# SUSITNA HYDROELECTRIC PROJECT

ACRES SPECIALIST CONSULTANTS PANEL

REPORT ON SPECIALIST CONSULTANT  
PANEL MEETING NO. 4  
NOVEMBER 18, 1981

SPECIALISTS CONSULTANTS PANEL MEETING NO. 4  
BUFFALO, NEW YORK - NOVEMBER 18, 1981

WATANA SADDLEDAM CROSS-SECTION

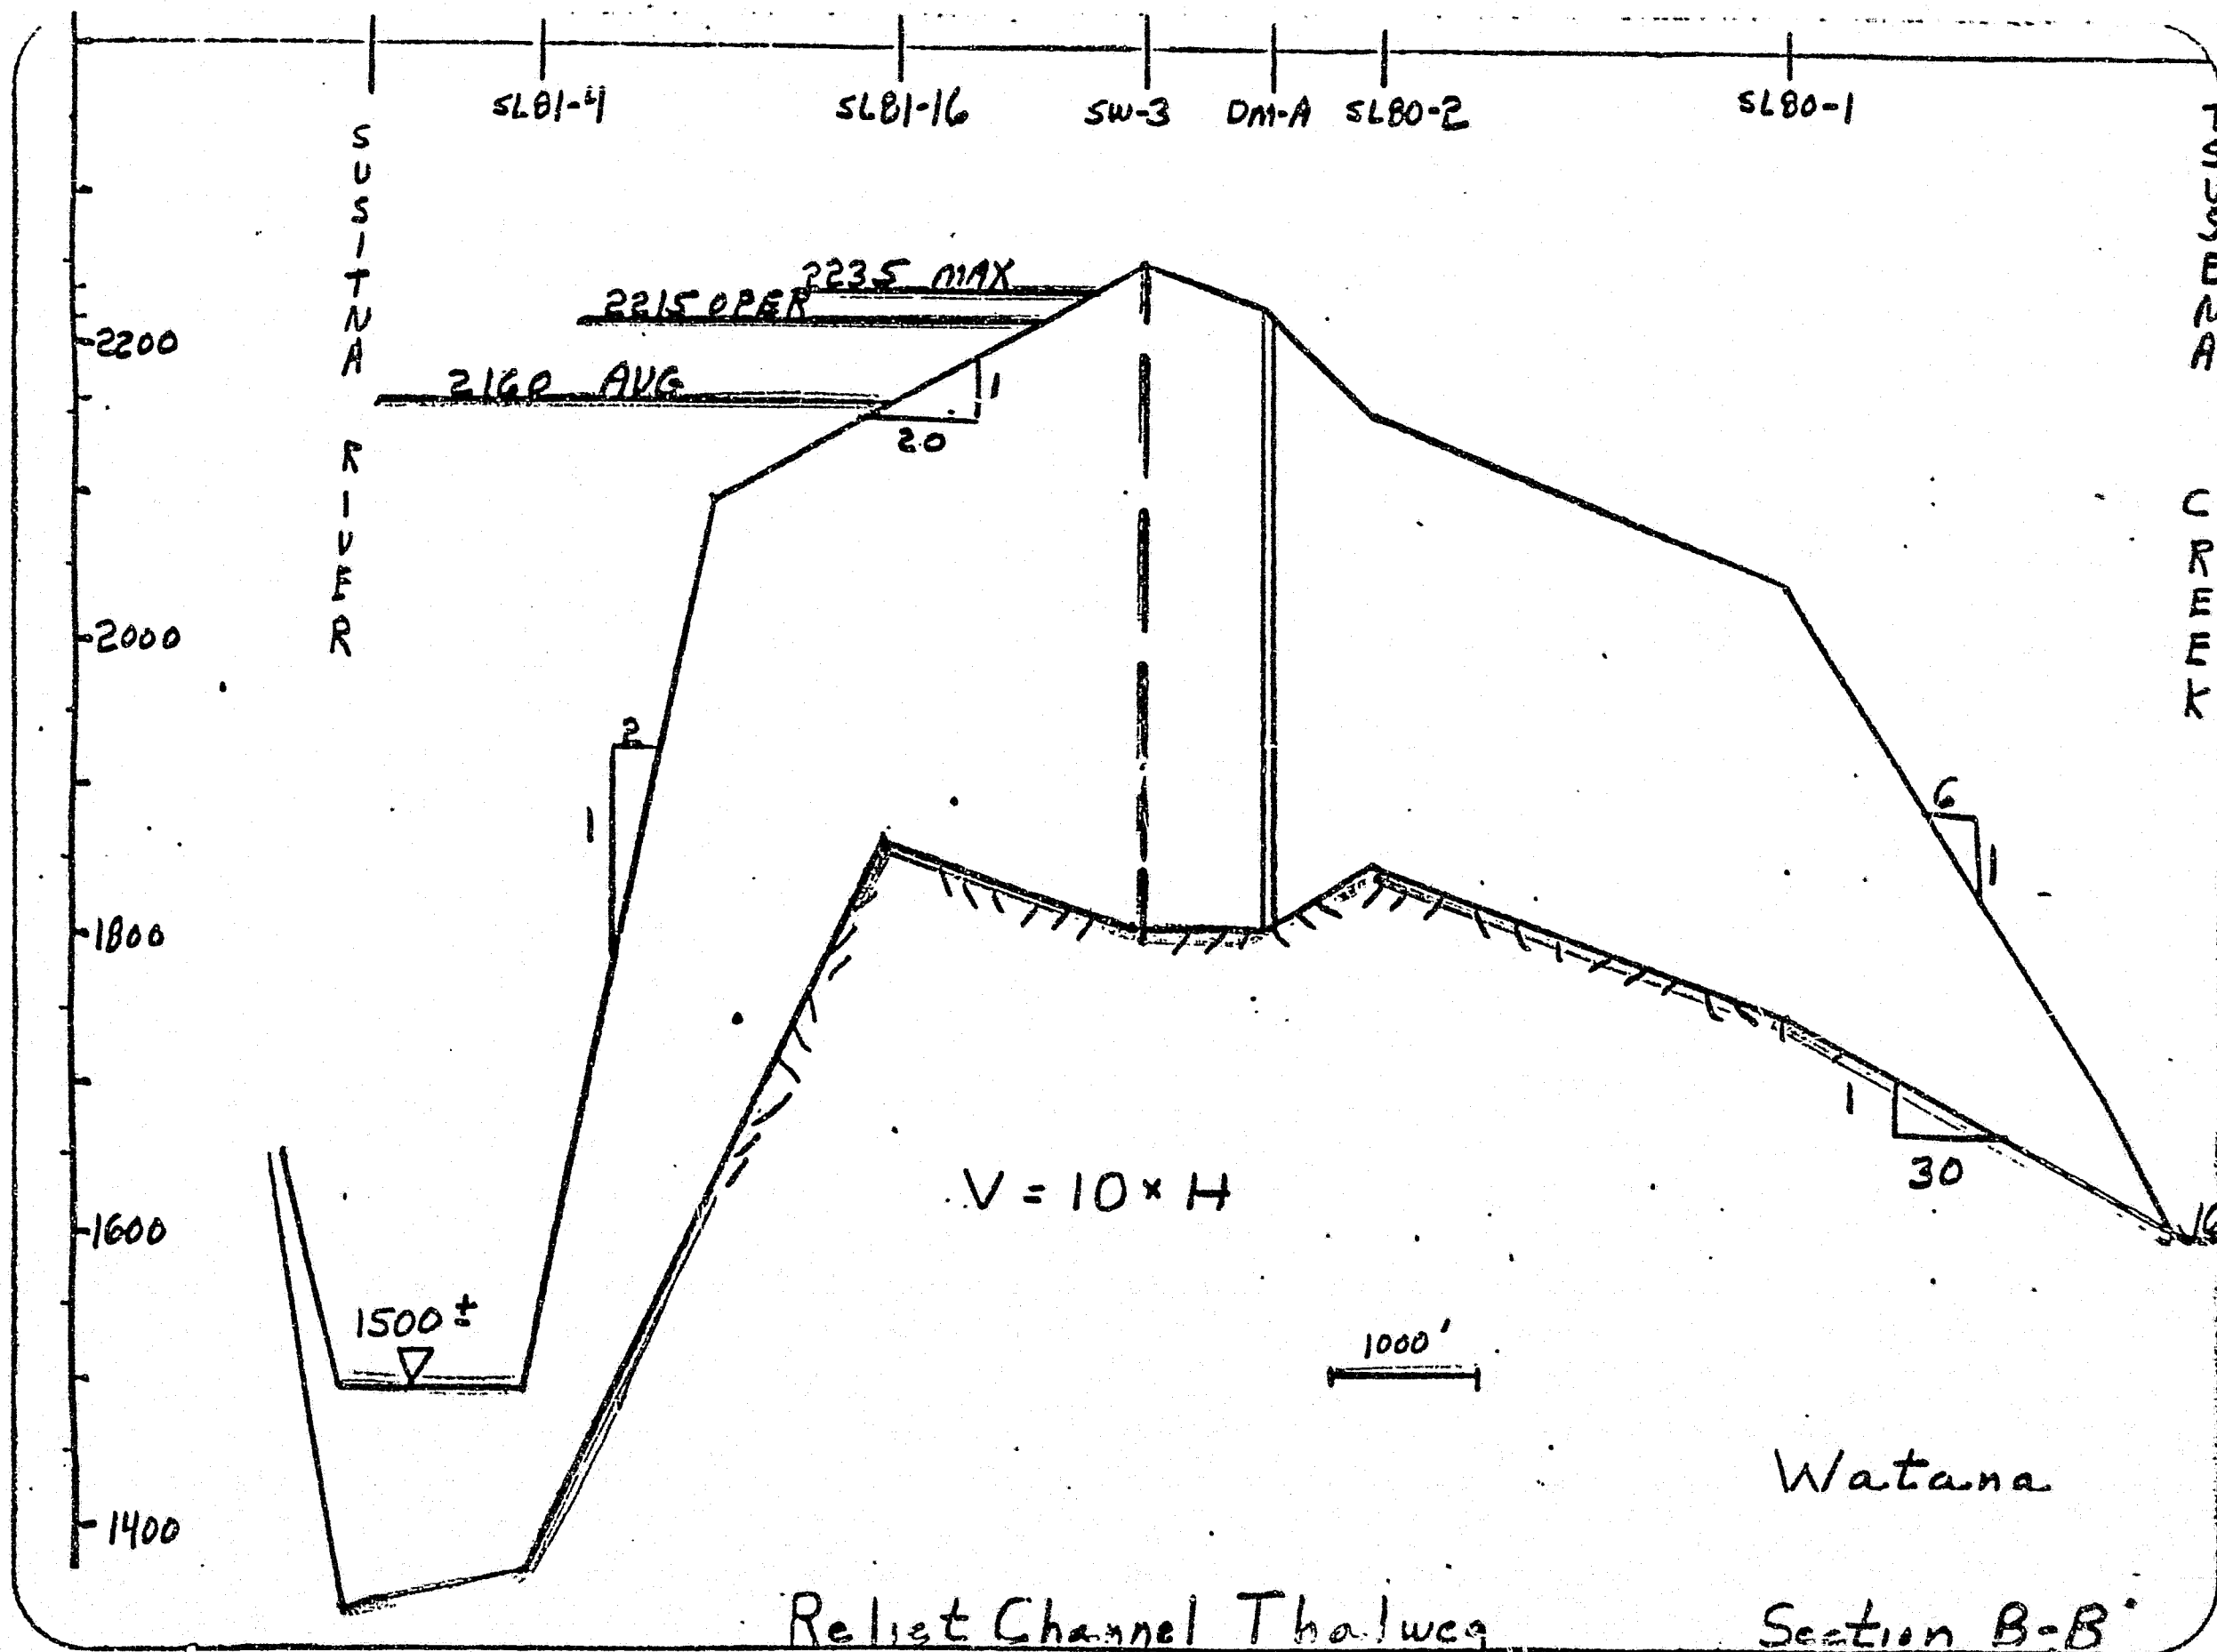
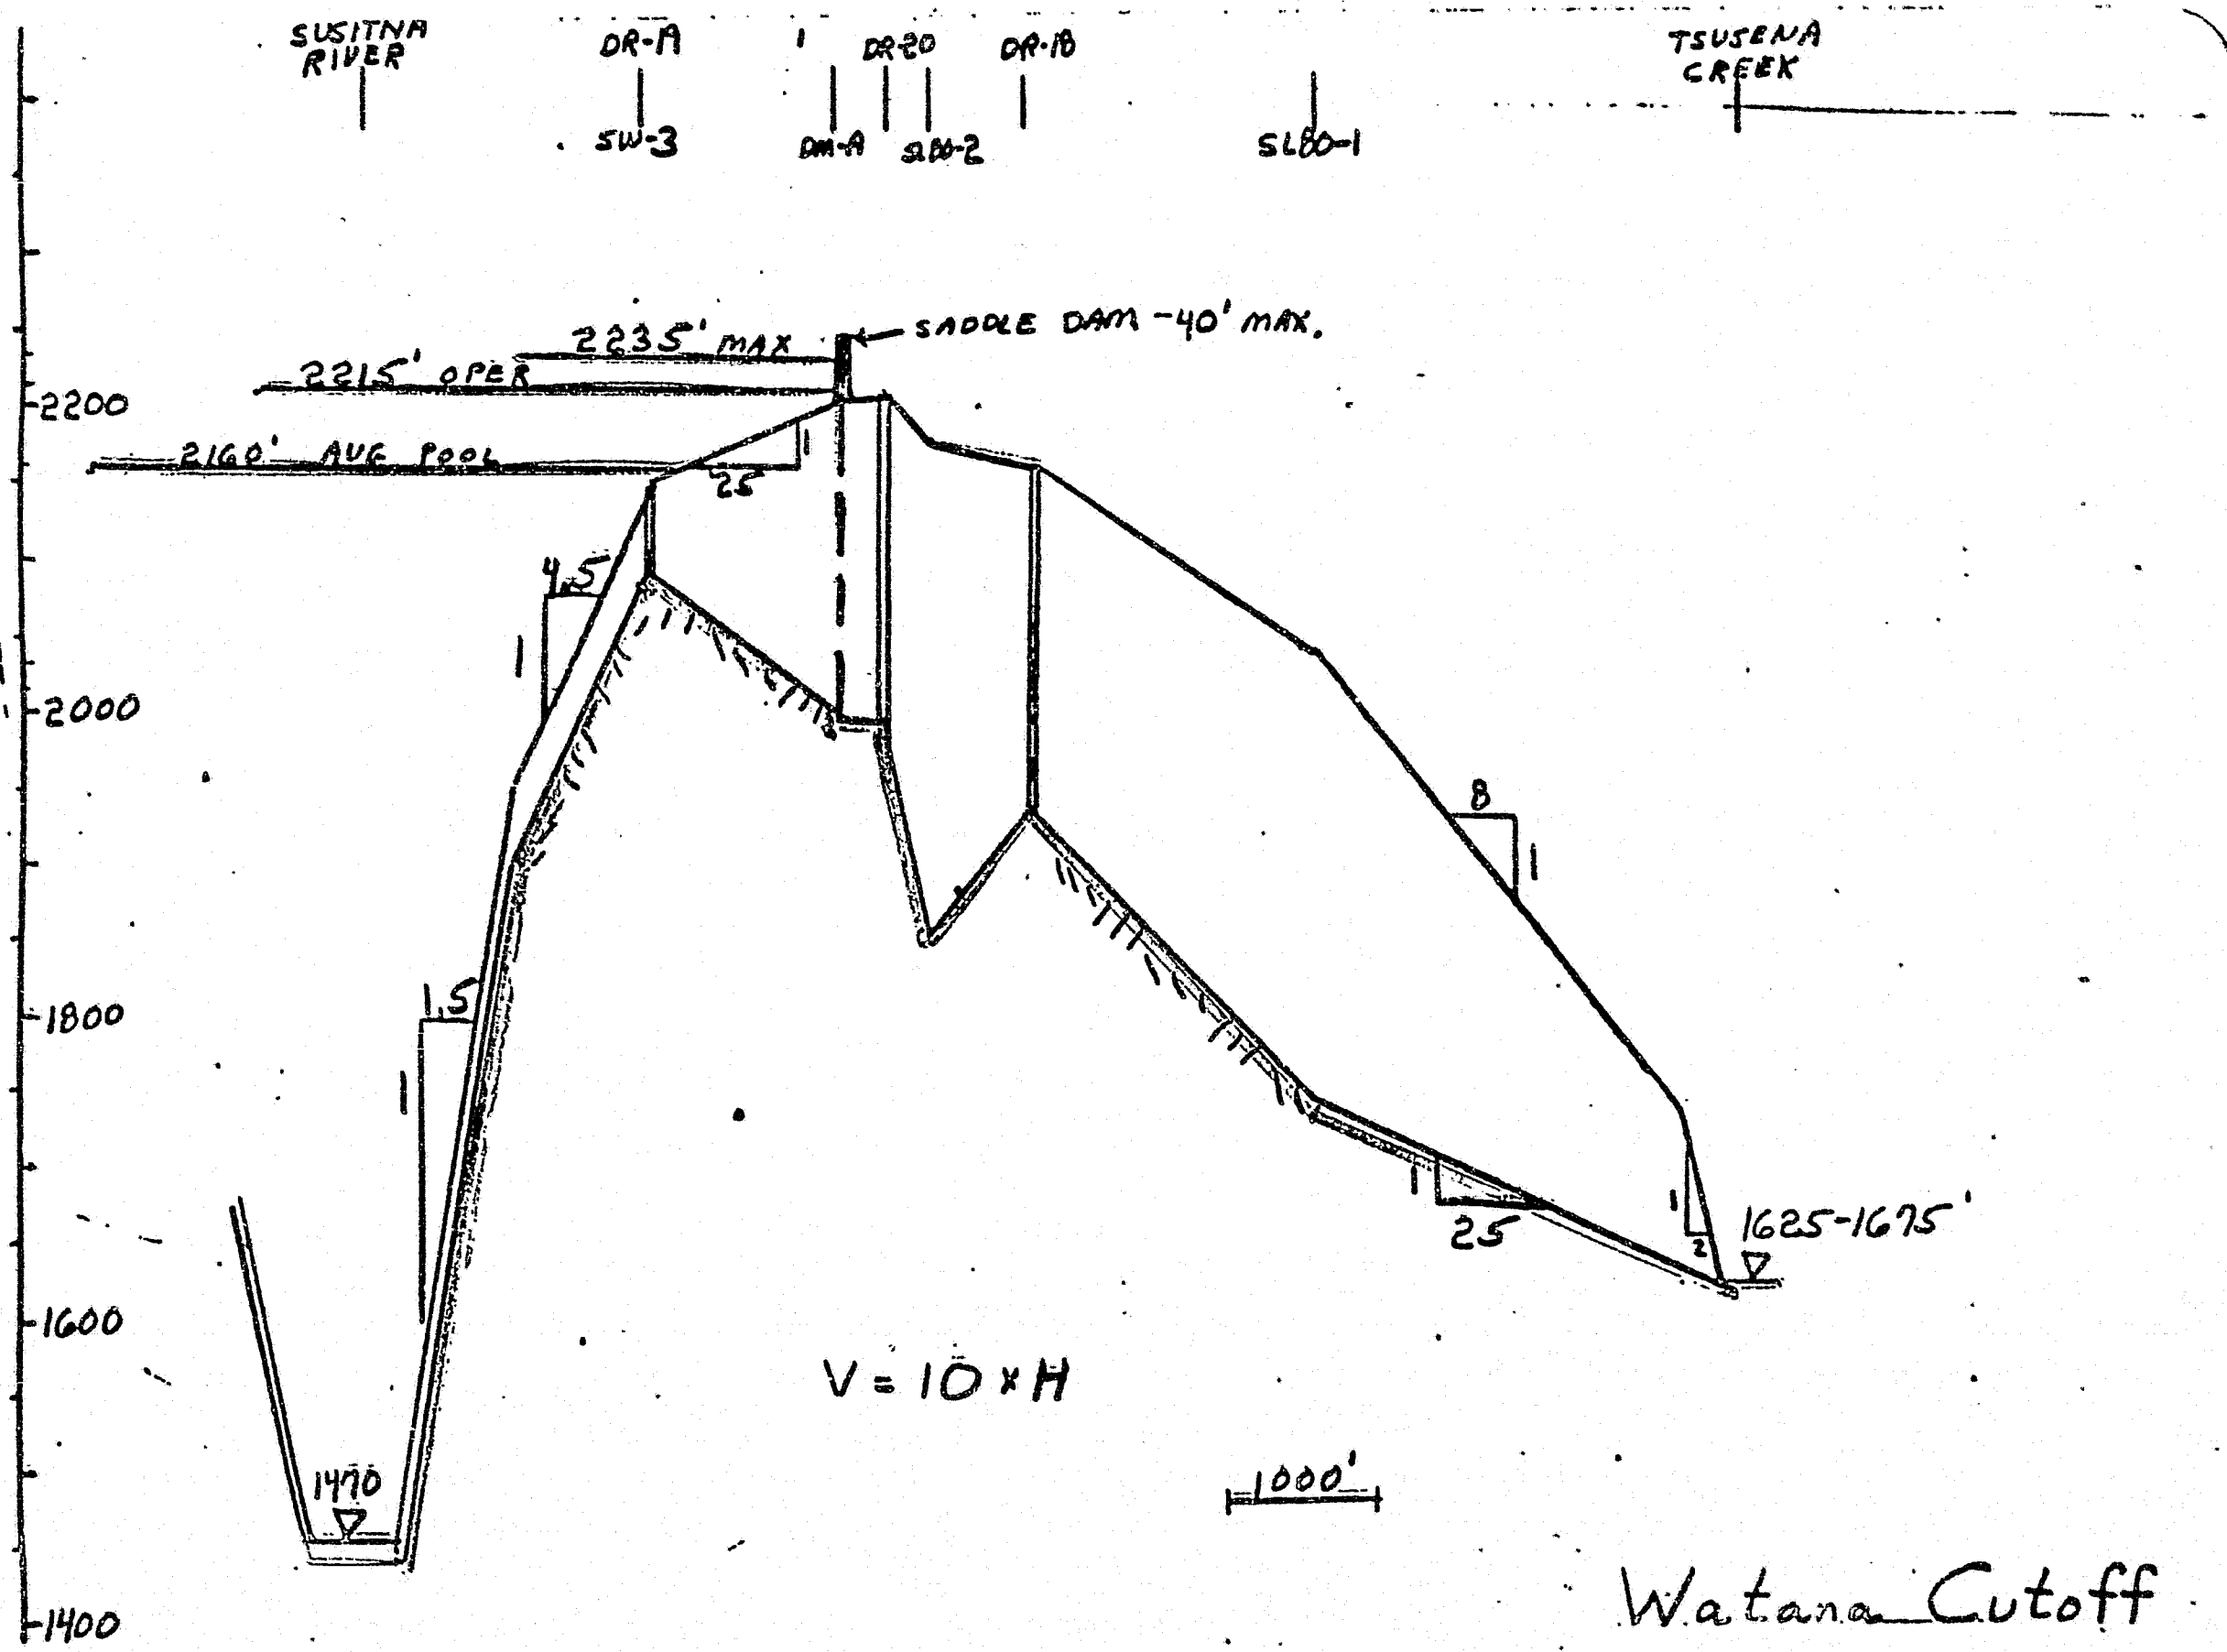
Dr. Hendron could not see liquefaction being a problem except in isolated zones which might lead to settlement of the saddle dam. J. Lawrence stressed that only 15 feet of water were retained by the dam, and suggested that an allowance for settlement could be built into the dam.

Dr. Hendron said that the liquefaction will not be regular and therefore the settlement will lead to cracking. Acres said that only an 1,100-foot length of the saddle dam is normally wetted.

Dr. Peck was not happy about the Watana saddle dam, even 10 feet high, and did not think that the slurry wall and grouted cutoff of the relict channel could be justified. He thought that the height of the main dam should be fixed on overall economic grounds.

The panel recommended that the reservoir level be adjusted to eliminate the need for a saddle dam. The PMF water level would then be fixed by the lowest ground level in the relict channel area with suitable freeboard allowance.
